TOWN OF CARMEL
PLANNING BOARD

PLANNING BOARD AGENDA
JULY 31, 2019 – 6:30 P.M.

Craig Paepre, Carmel Planning Board Chairman & Members of the Board
Town Hall
60 McAlpin Ave
Carmel, NY 10512

Chairman Craig Paepre and Members of the Planning Board
Town of Carmel Planning Board
60 McAlpin Avenue
Mahopac, New York 10541

Drawn: [Signature]
Scale: NOT TO SCALE
Date: 05/16/2019
Title: [Signature]
Sheet: C-902

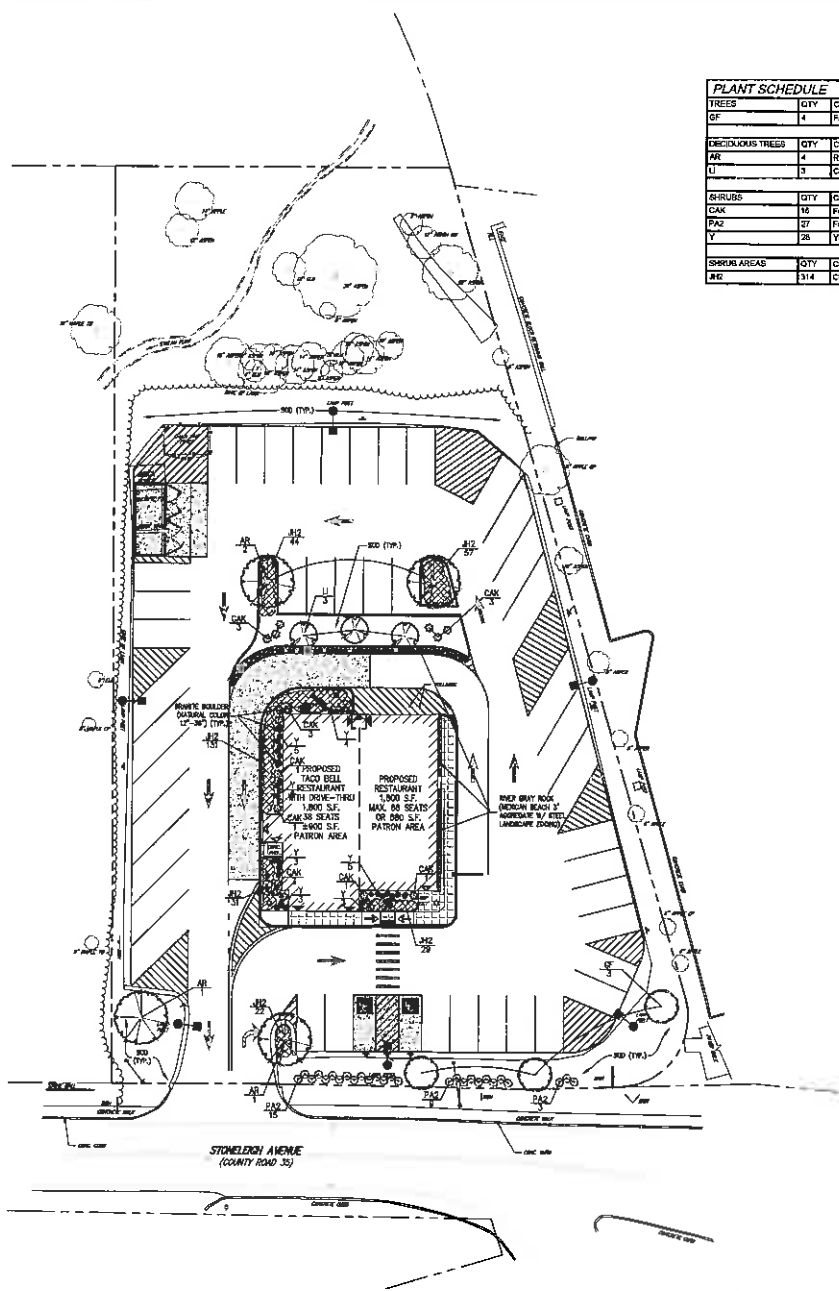
The note on Drawing C-100 identifies proposed mill and resurface (typical), however the Pavement resurfacing detail on C-900 has a Truing and leveling as required. Please bring these in conformance with each other. It is recommended that milling be performed.

We are indeed calling out milling and resurfacing over the entire lot, however in localized areas truing and leveling may be required to provide a quality finished surface; hence the reason the detail is provided. Due to the nature of the milling operation these areas cannot be identified prior to construction.
